**MEIJER RHH**  
**1495 N. ROCHESTER RD.**  
**ROCHESTER HILLS, MICHIGAN 48307**  
 (APPROX. 3.92 ACRES) LOCATED IN THE CITY OF ROCHESTER HILLS, COUNTY OF OAKLAND, AND STATE OF MICHIGAN

**ROCHESTER HILLS MICHIGAN**  
**J2024-0177**  
**PSP2024-0026**  
 Original Submission  
 Received 8/2/2024  
**City of Rochester Hills Planning & Economic Development**

**Site Plan Review**  
 Reviewed for compliance with City Ordinance, Building and Fire Codes  
 Conditions and mark-ups noted throughout plan set must be addressed prior to final approval

**USE DESCRIPTION: CONDITIONAL USE**  
**AND SITE PLAN REVIEW**  
**DATE: 08/02/2024**  
**PROJECT NUMBER: TBD**

D1 6'-0" VINYL SCREEN FENCE  
NTS

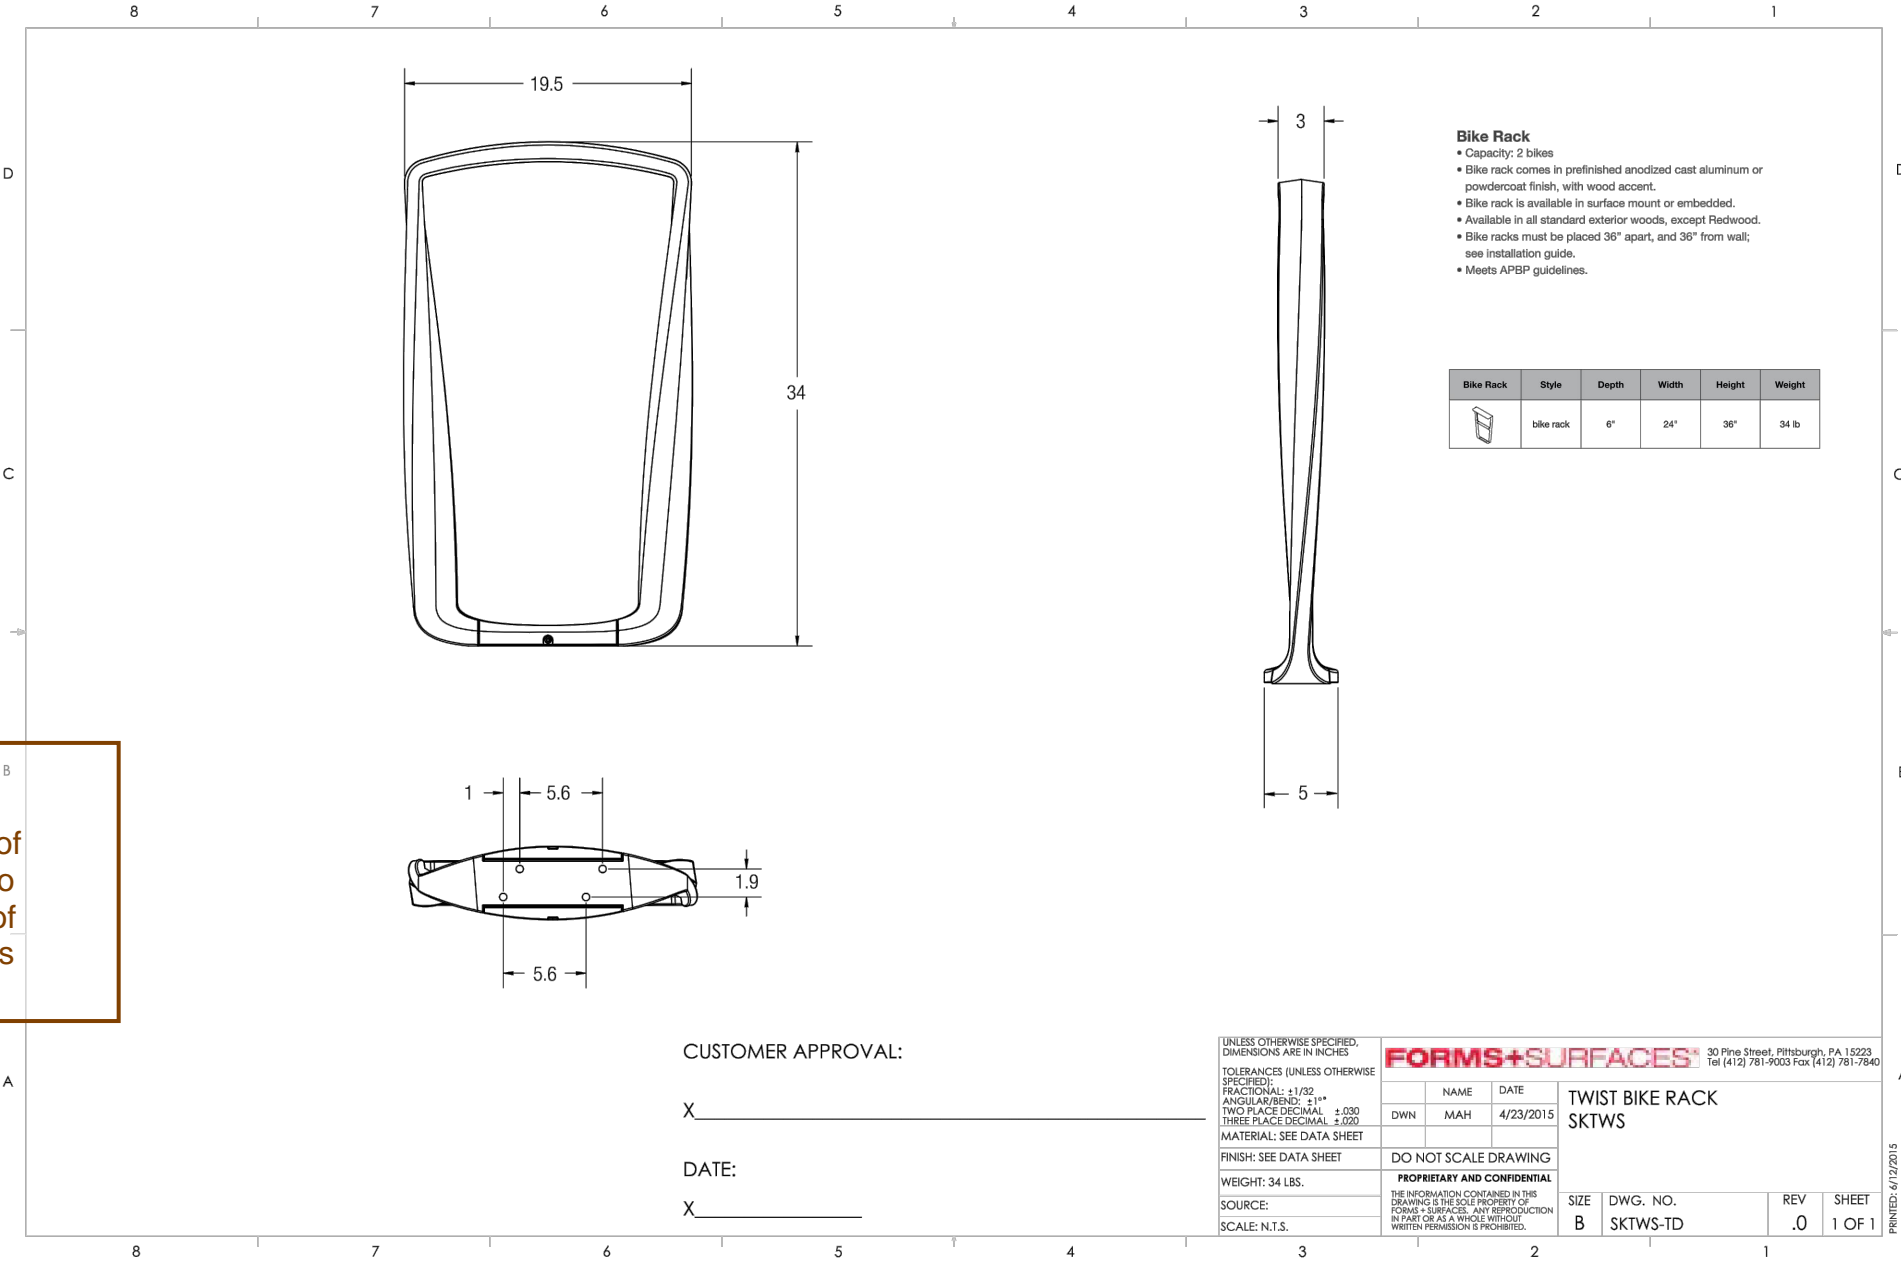
Provide color  
Modifications of fence may also require City of Rochester Hills approval.

A1 OVERALL FLOOR PLAN  
A-001 SCALE: 1/16" = 1'-0"

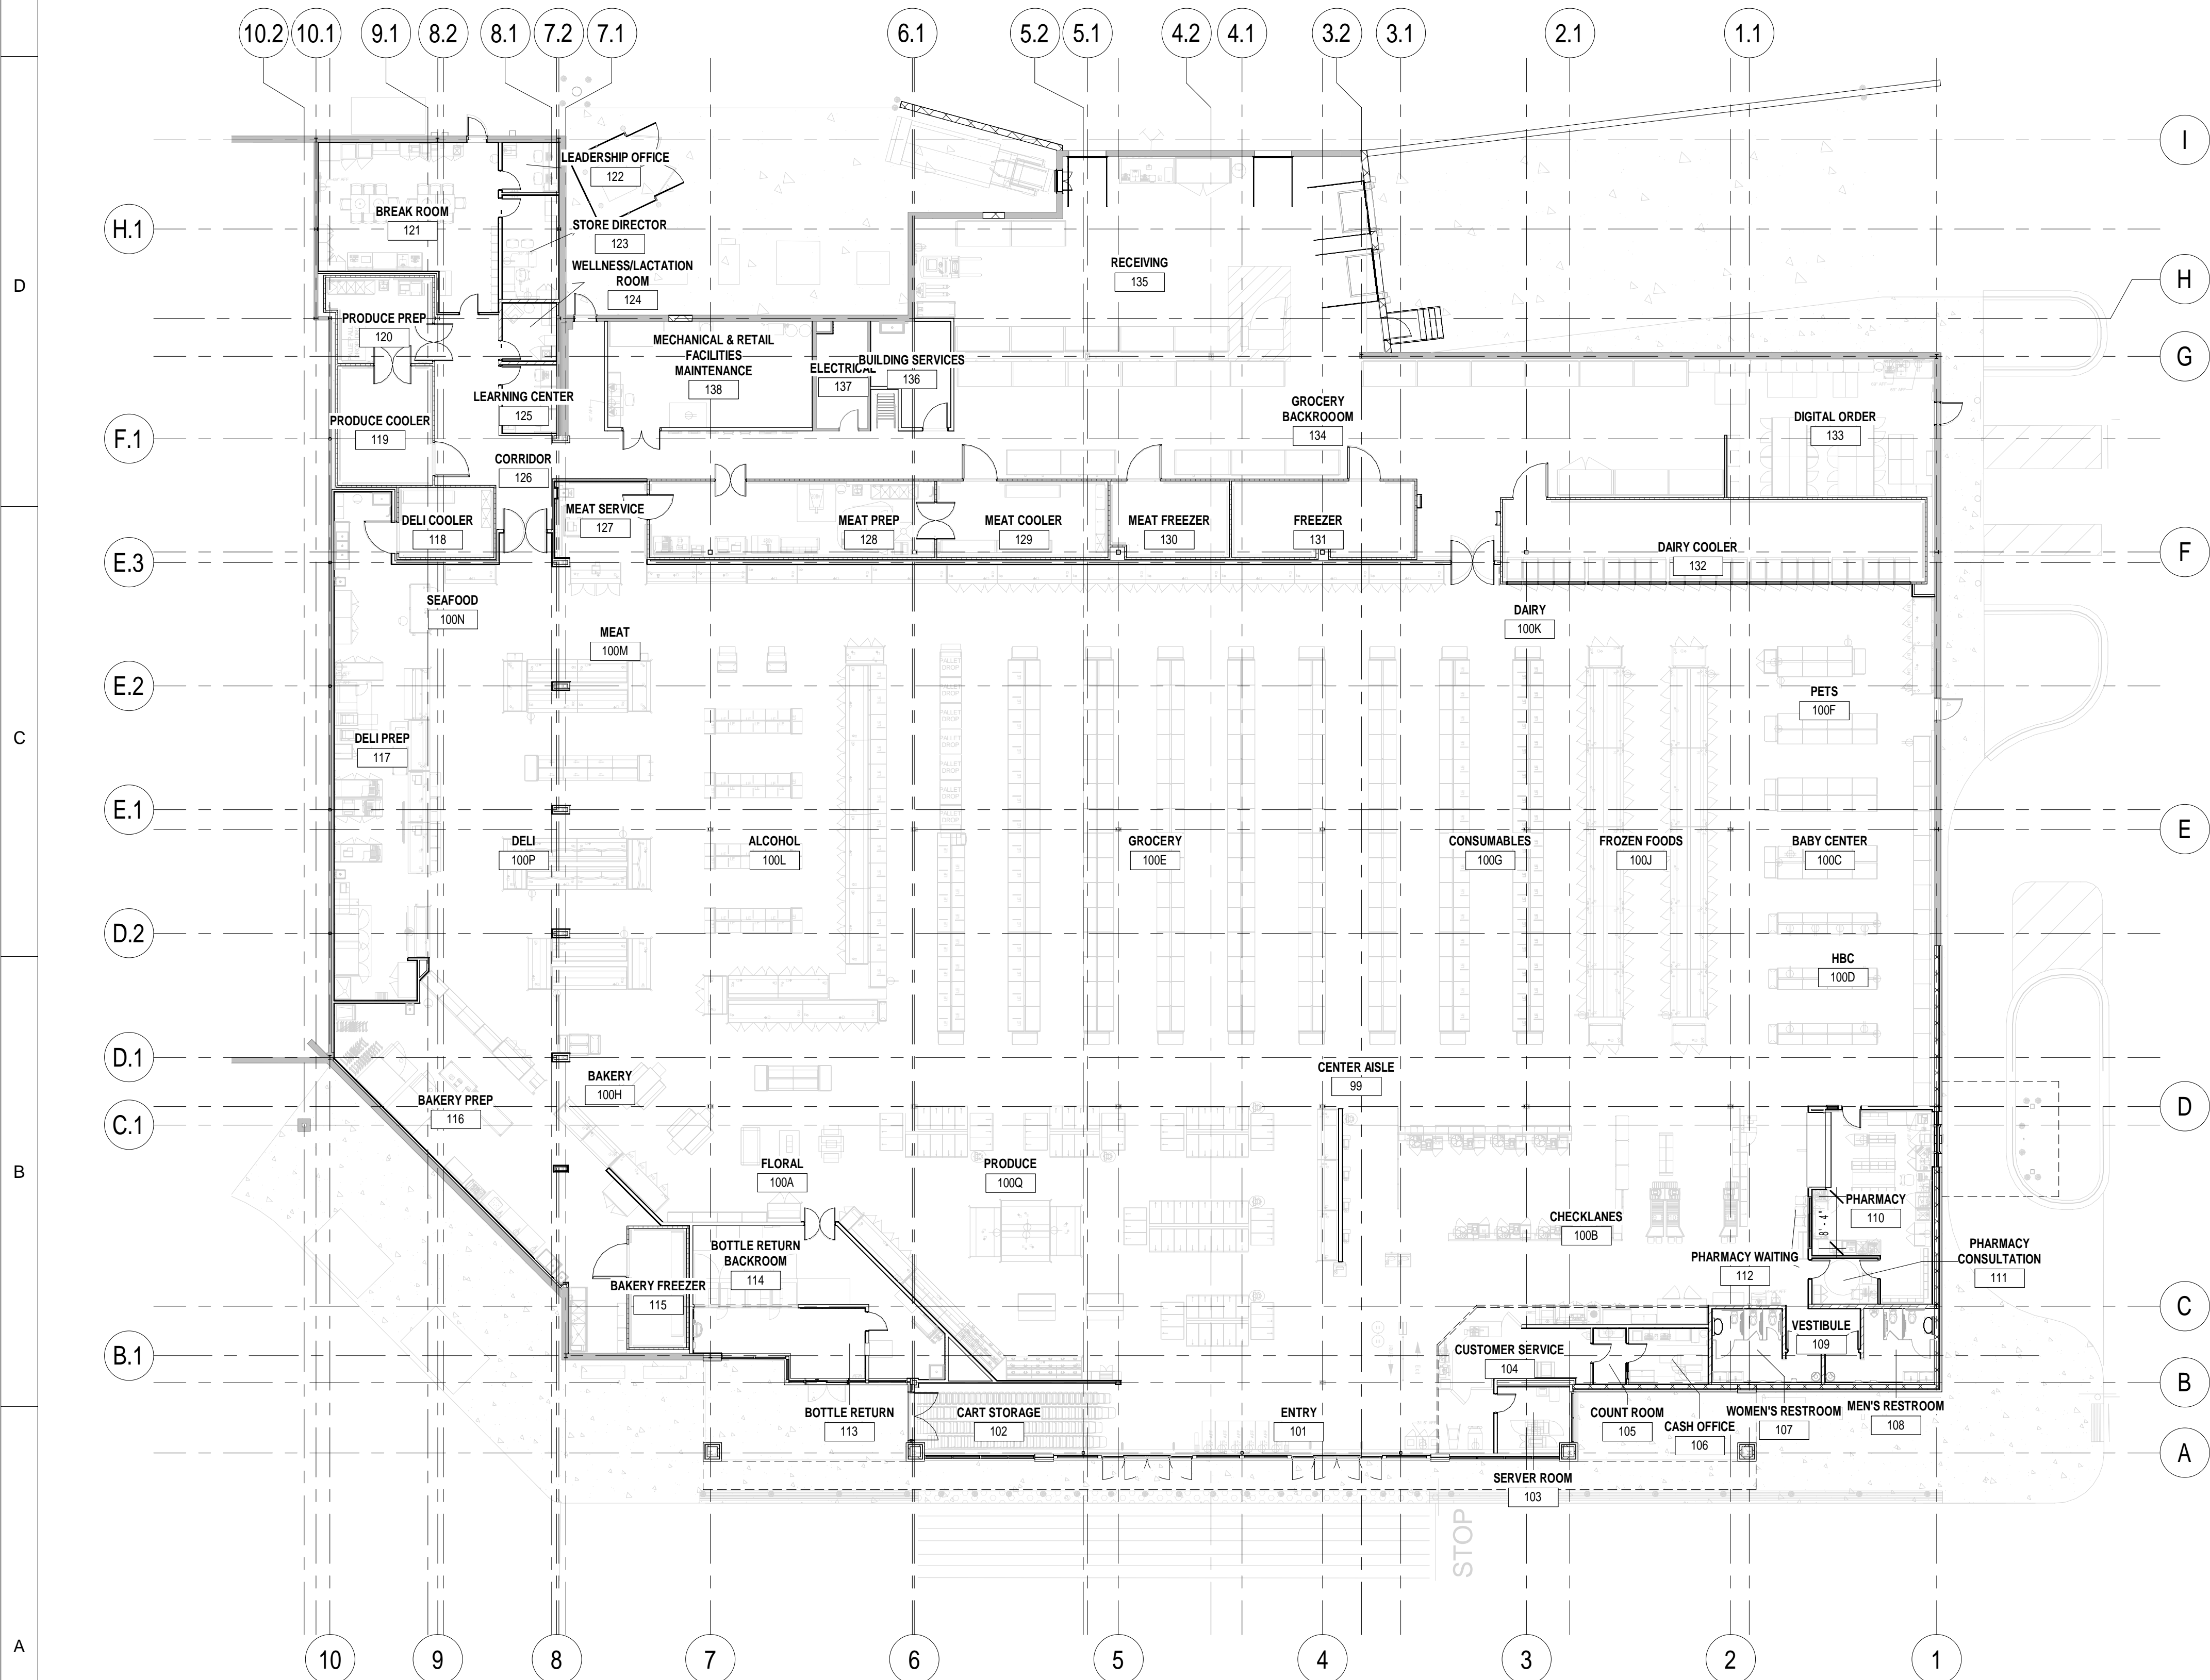
Overall building height of 37 feet to be revised to 30 feet with no more than 4 foot parapet pursuant to conversations with applicant
